FINAL
MONITORING REPORT
2021 (Year 3)

MAJOR HILL STREAM AND WETLAND MITIGATION SITE

Response to Monitoring Year 3 (2021) DMS Comments

Major Hill Mitigation Site (DMS #100015)
Cape Fear River Basin 03030002, Alamance County
Contract No. 100015

Major Hill Soil Temperature
Year 3 (2021 Data)

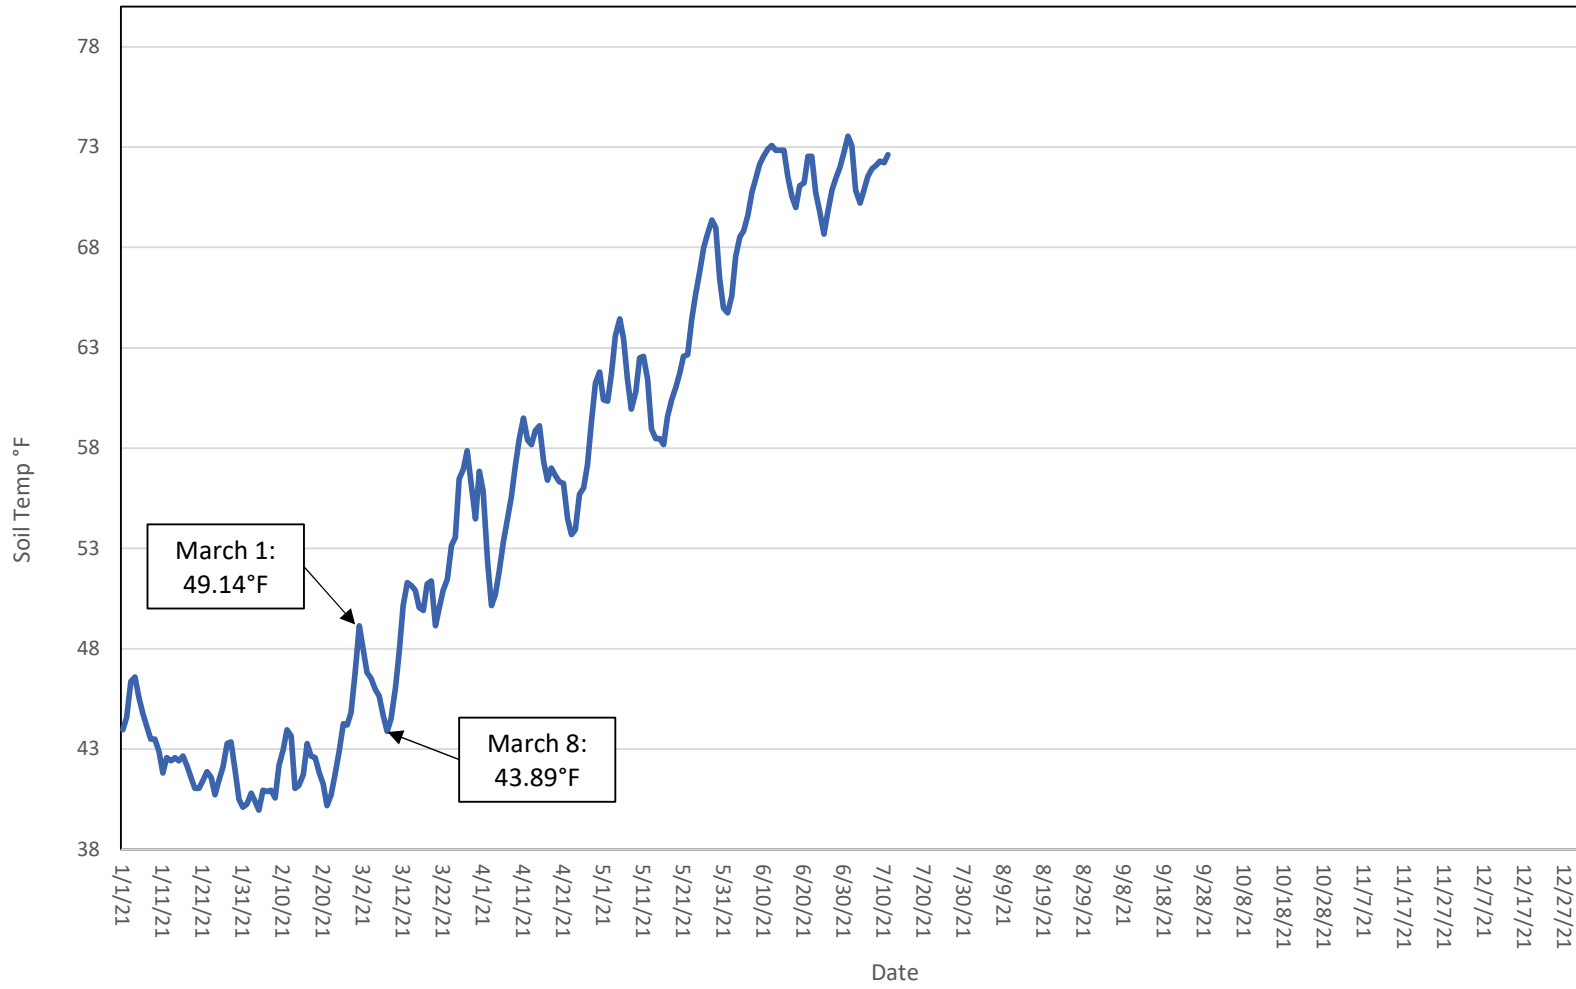
1. The soil temperature data needs to be included in the report, represented with a time series, and must be corroborated with vegetative indicators as determined in the Mitigation Plan.
Response: A soil temperature graph is included in Appendix E. This data is in the gauge data workbook in the digital submittal.
2. Please include a figure displaying the 30th and 70th percentiles of monthly precipitation compared to observed monthly precipitation.
Response: This figure is included in Appendix E. The excel data is included in the digital submittal.
